RE: Legacy NAA Apartments 2
Conceptual Grading and Drainage Plan
Engineer's Stamp Date: 02/08/18
Hydrology File: C18D083

Based upon the information provided in your submittal received 02/02/2018, the Conceptual Grading and Drainage Plan is **not** approved for Site Plan for Building Permit. The following comments need to be addressed for approval of the above referenced project:

C-1

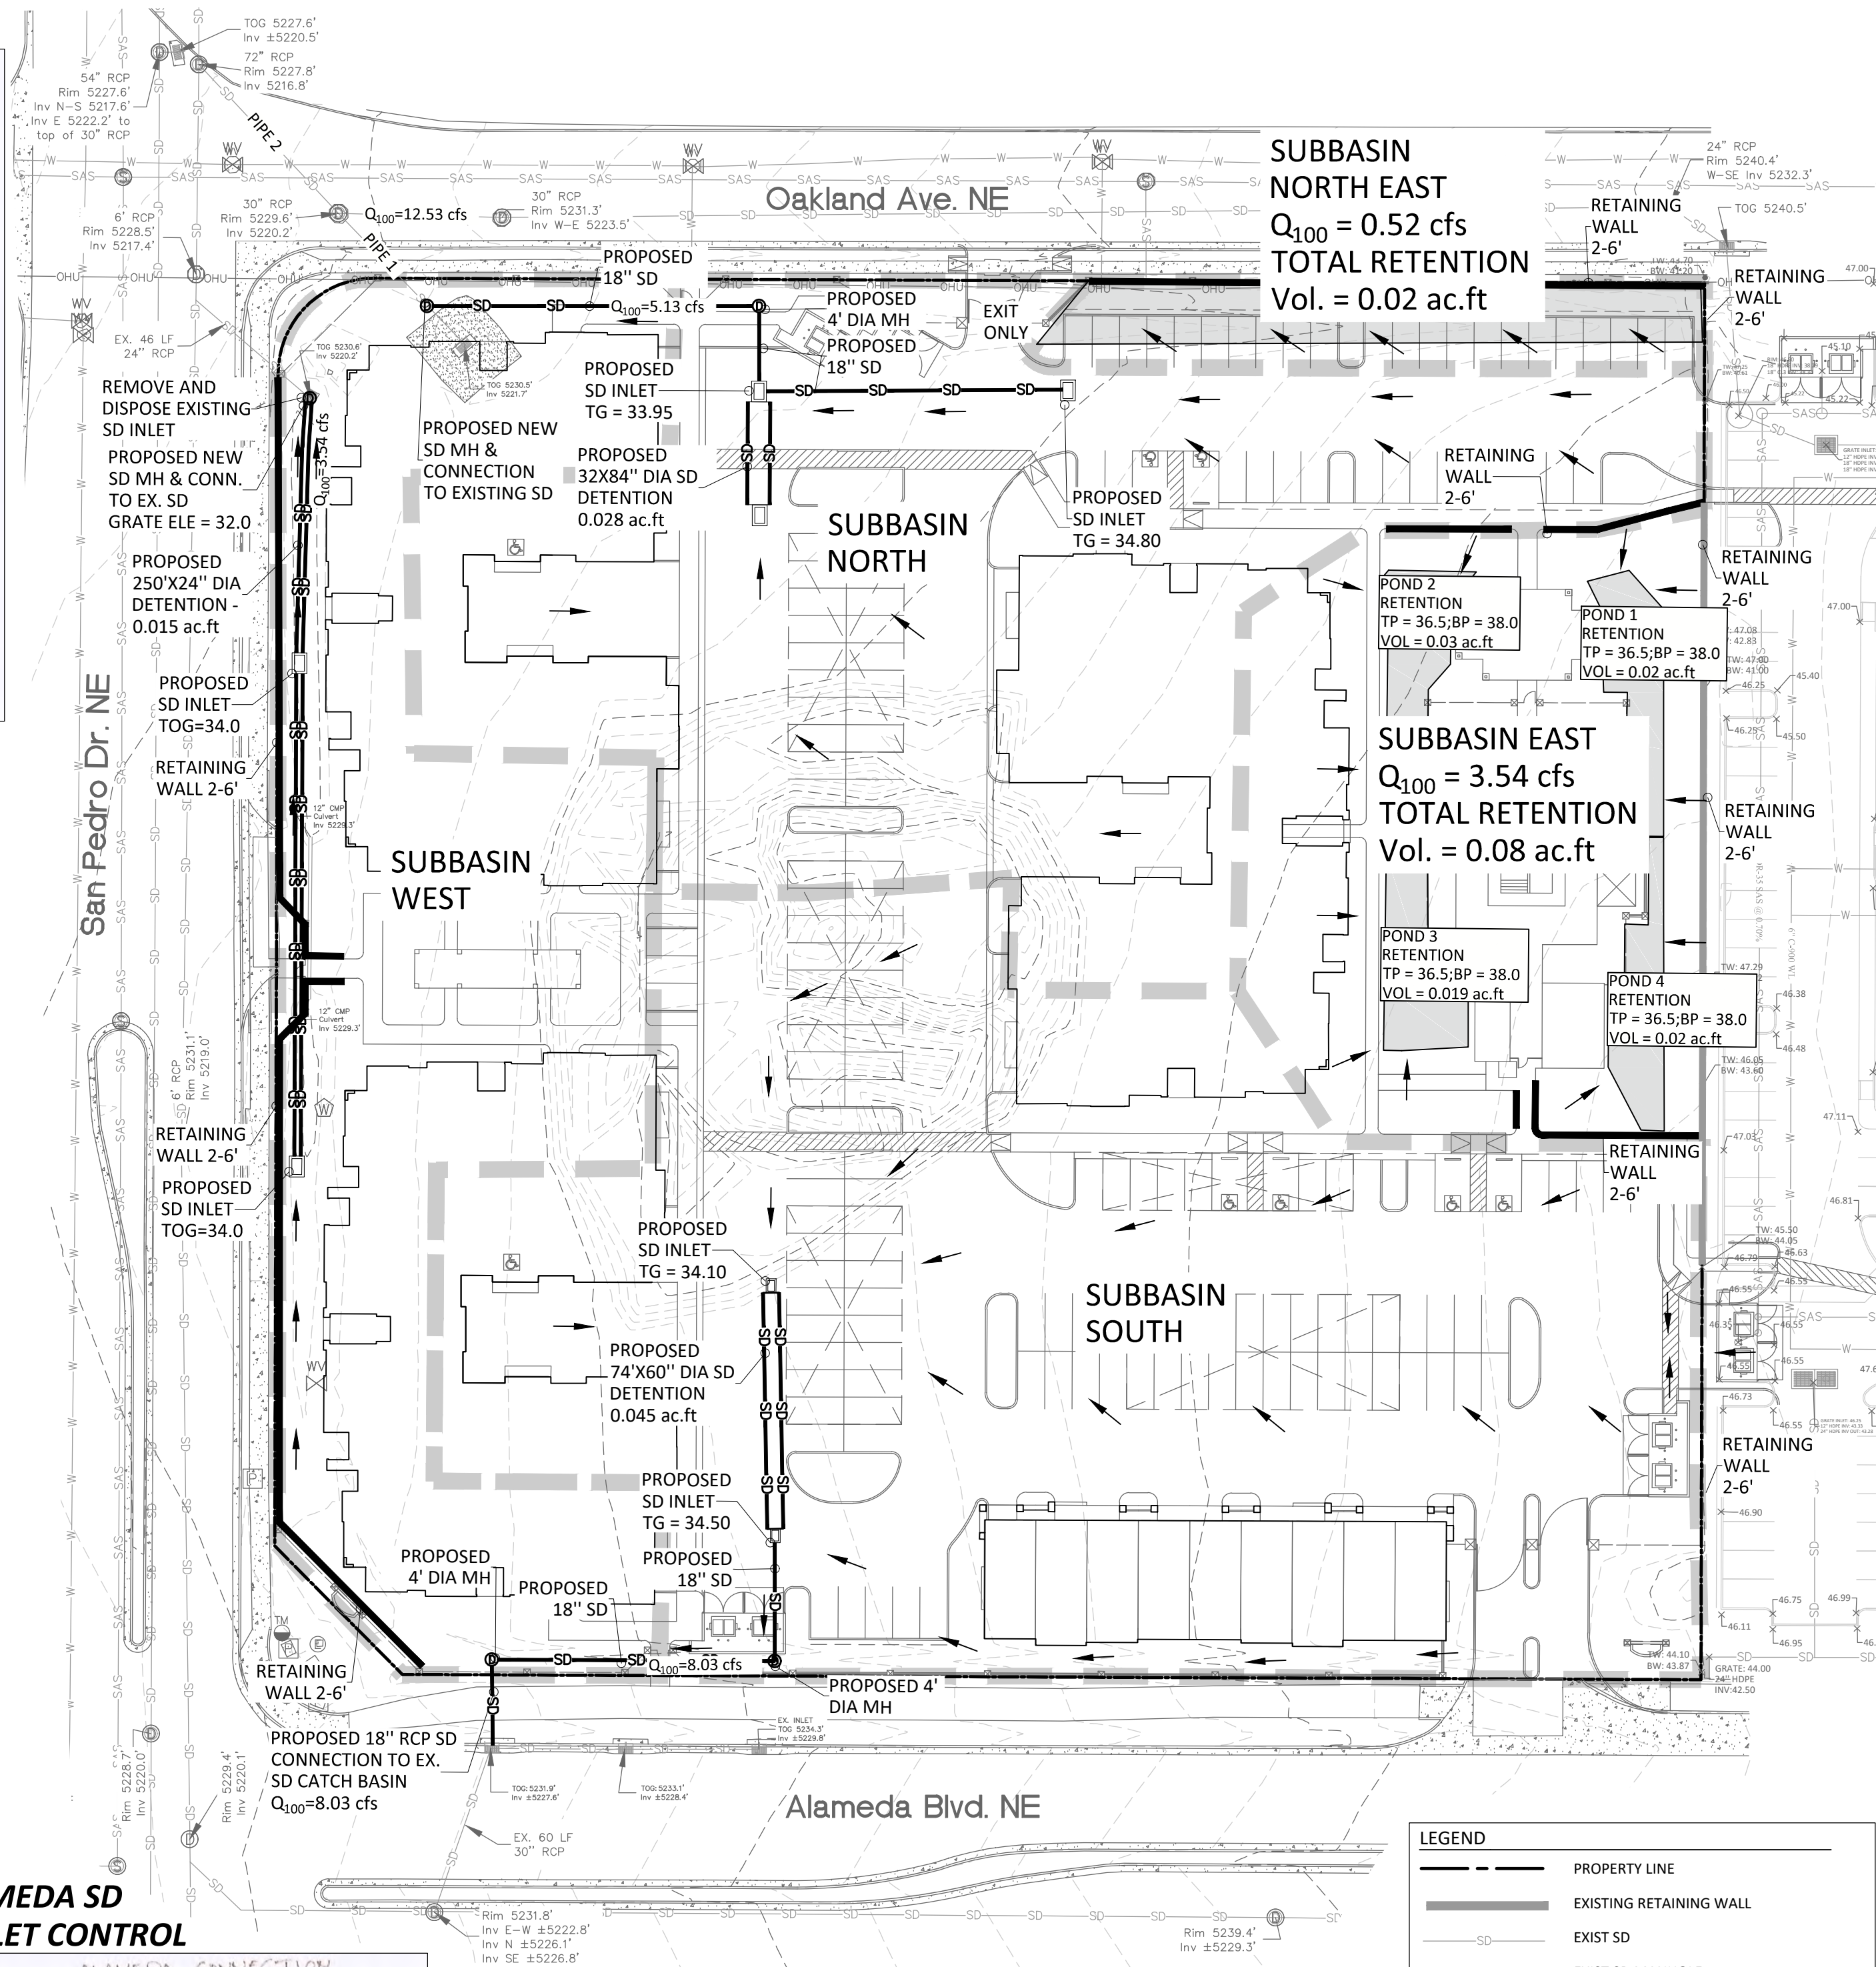
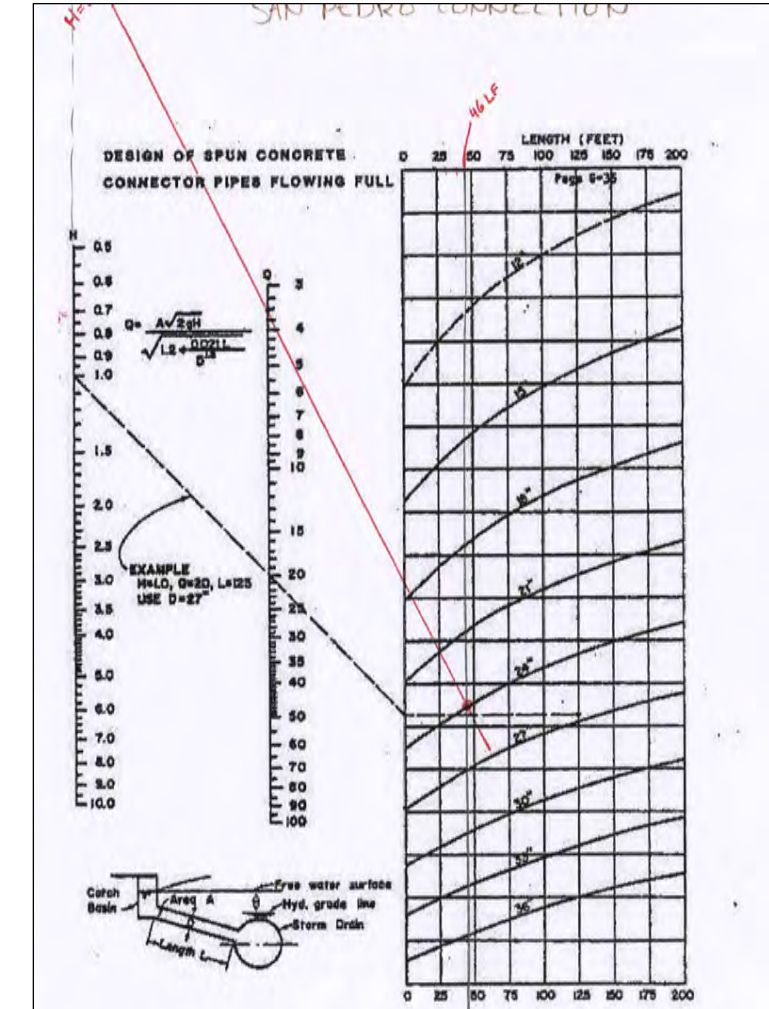
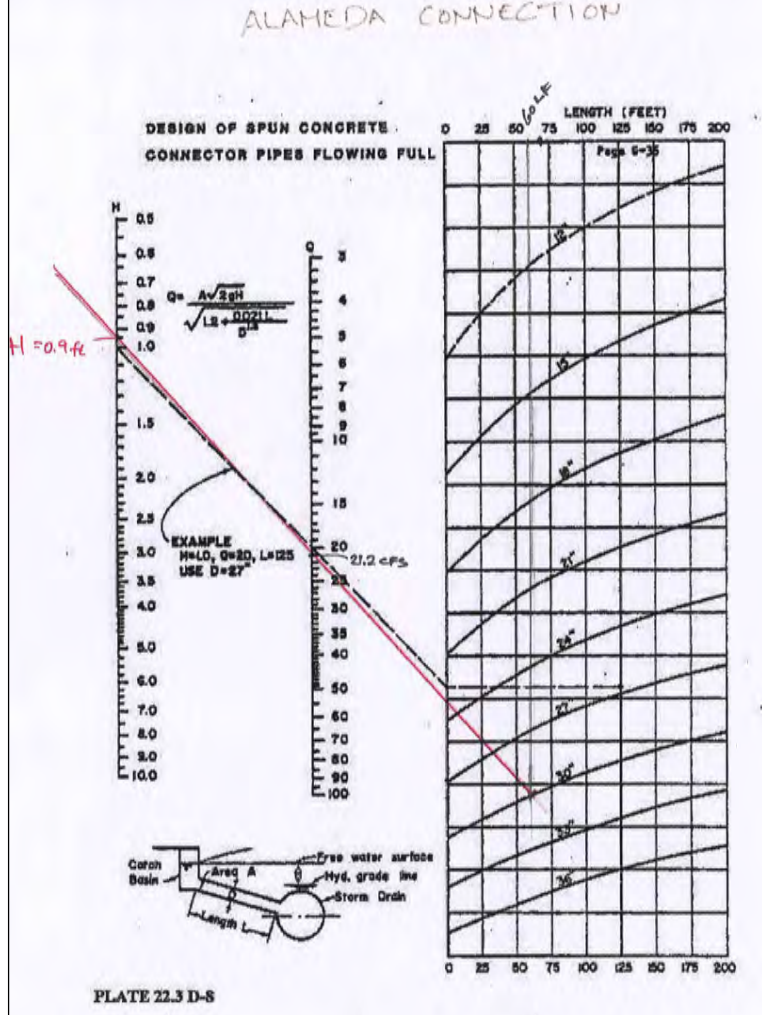
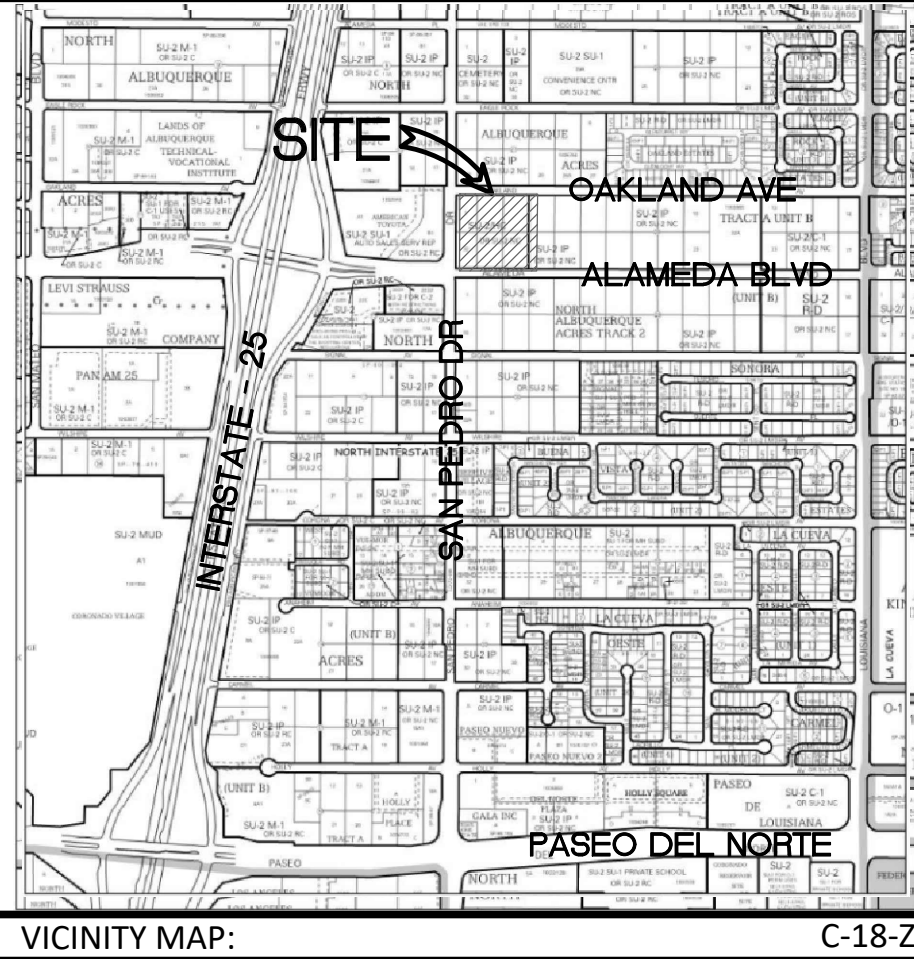
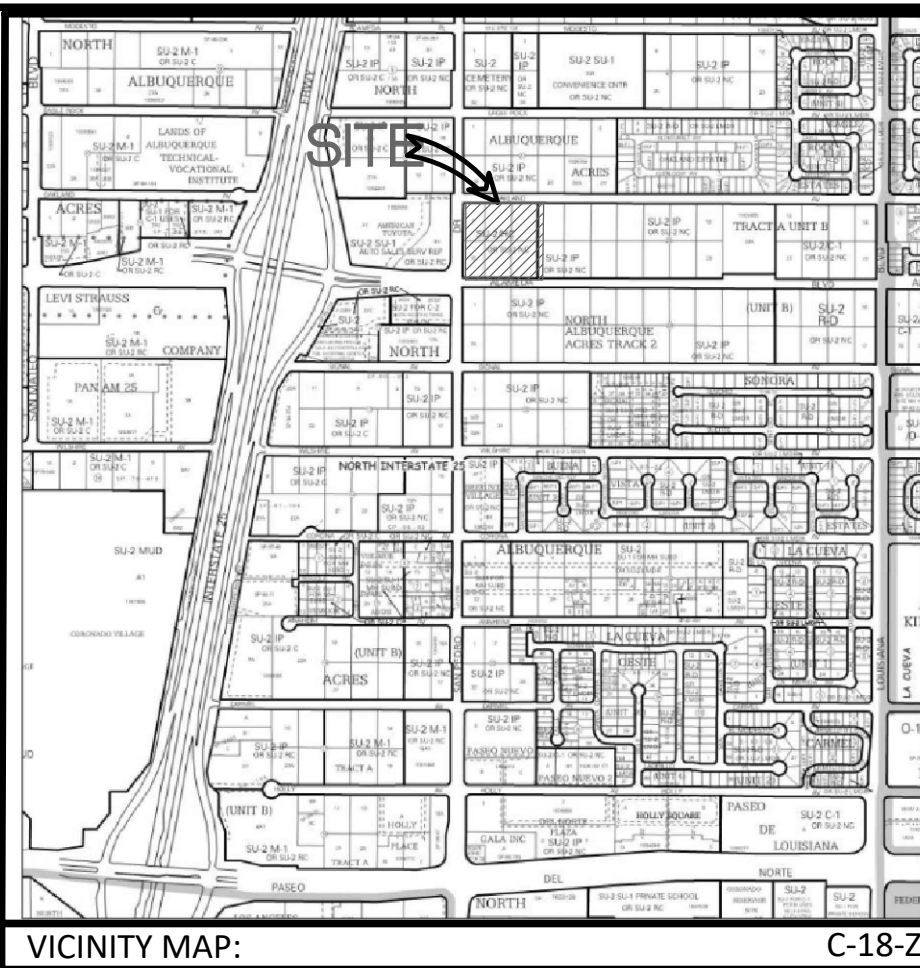
1. Please add the word "Conceptual" to the sheets title and add a note stating "Not for Construction".
2. Sheet C-1. Under Background, the southern half of the property is tying into the existing storm inlet on Alameda Blvd. This was installation with modifications to the NAAMDP under a design analysis report "Alameda Blvd San Pedro to Wyoming Project #7663.91 by Thompson Engineering dated January 2012. This report revised the allowable discharge for the southern half of the property to 3.82 cfs/ac. So the 2.21 ac will have an allowable discharge of 8.44 cfs.

3. Sheet C-1. The Q_{100} for Subbasin East should be 2.09 cfs.
4. Sheet C-1. Please clarify if the retaining walls along the East property line are existing or proposed. If it is proposed, then please show a cross section.

5. Sheet C-1. Please show the retention pond volume calculations for both Subbasin Northeast and Subbasin East for the 100 year – 10 day.

6. Sheet C-1. For Subbasins North, West, and South, please show the first flush volume within the landscape areas. The first flush volume is for water quality purposes. Having this volume just within underground pipes does not fulfill the intent of the first flush basins. Please revise and show how the flows into and exists the first flush ponds.

C-2

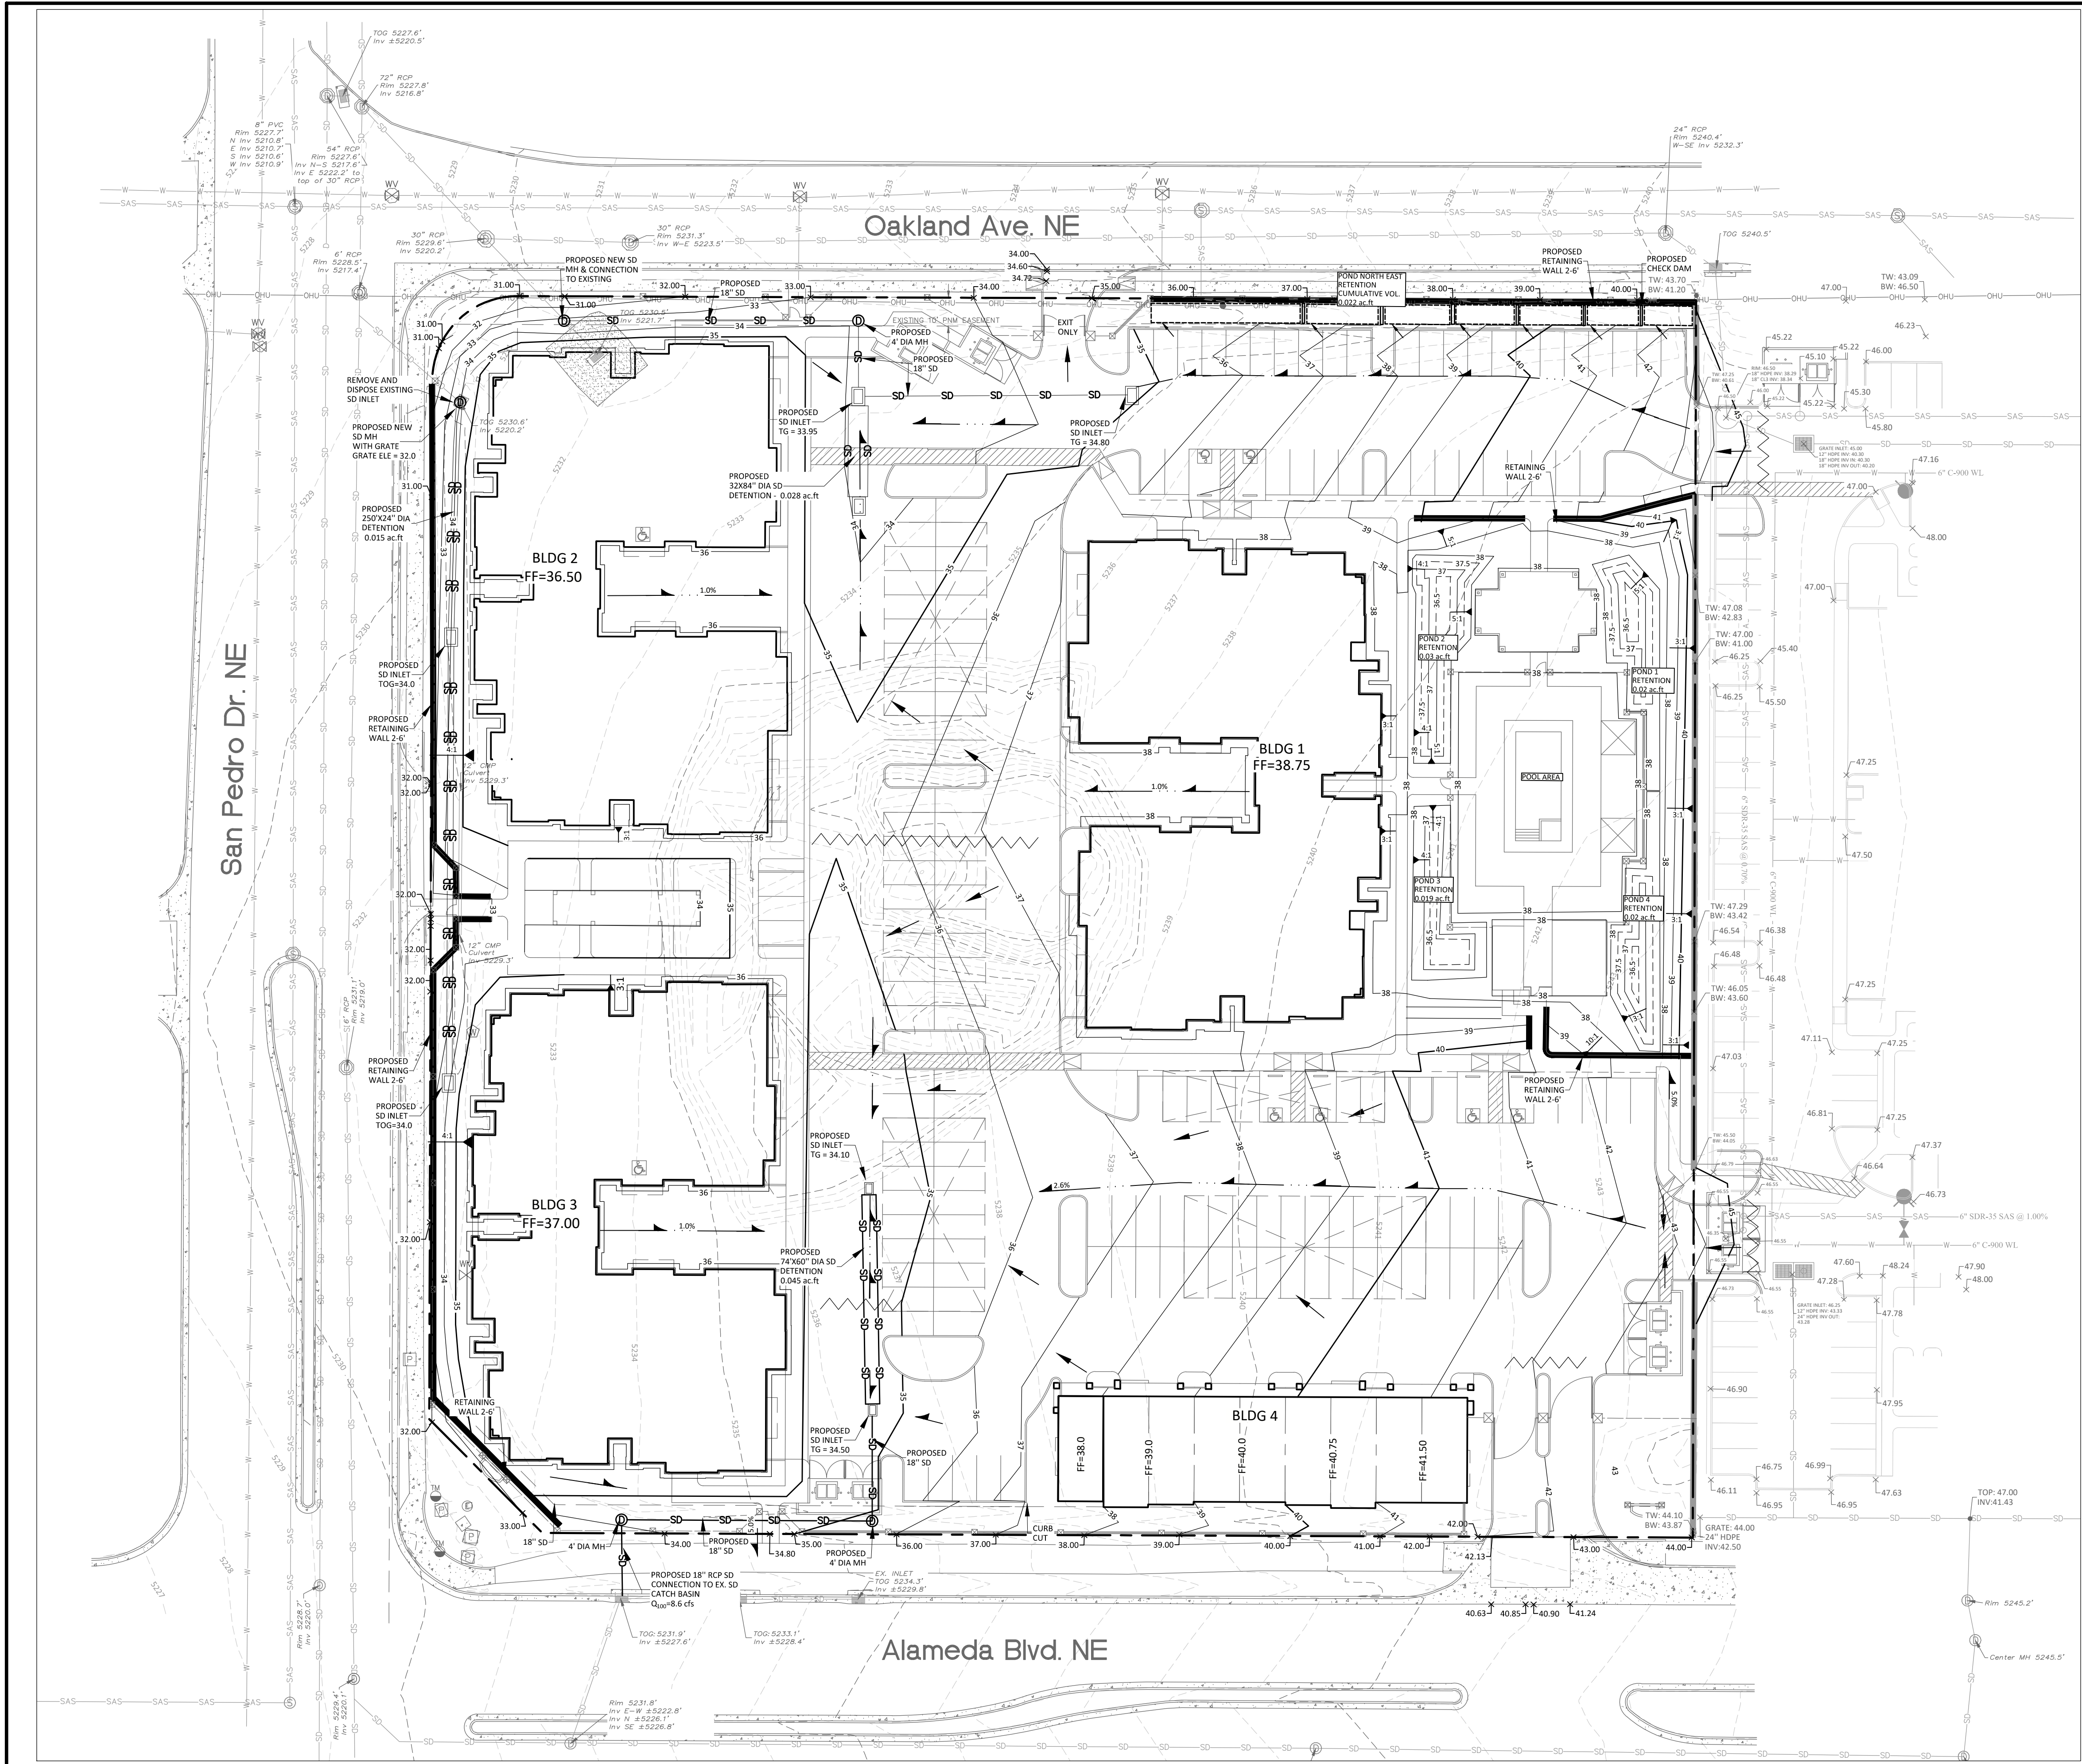
7. Sheet C-2. For Subbasin Northeast, the basin area and the proposed grading do not match. On Sheet C-1 there are drainage arrows starting at the edge of the parking going to the retention pond. On Sheet C-2, the drainage from the south half of the parking goes to a swale along the edge of the parking and into Subbasin North. Please correct.

8. Sheet C-2. For Subbasin East, How is the drainage actually getting into the retention ponds? Especially the eastern pond. Should there be a connecting pipe between all three retention ponds? Please explain or correct.

9. Sheet C-2. For Subbasin East and Northwest, the retention ponds needs to have a spillway for the volume over the 100 – 10day. Please add spillway.
